Subject: 718 N. Turnbull Street
Metairie, Louisiana

At your request, we have reviewed reports that were prepared by experts engaged for the opposing side in your litigation with respect to the subject property. The reports that we reviewed are as follows:

- Ashton Avegno Professional Engineer Report dated August 2, 2016
- Titan Construction LLC Report dated August 3, 2016

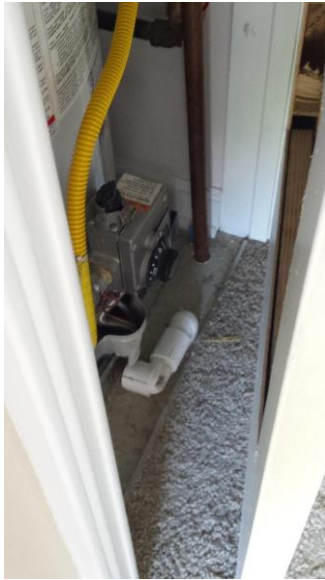
It is our understanding that there has been some discussion between the parties involved in this litigation regarding whether or not the roof has leaked. In our opinion, this photograph shows that the water heater vent penetration leaks, as evidenced by the rusting and damages visible at the top of the water heater.
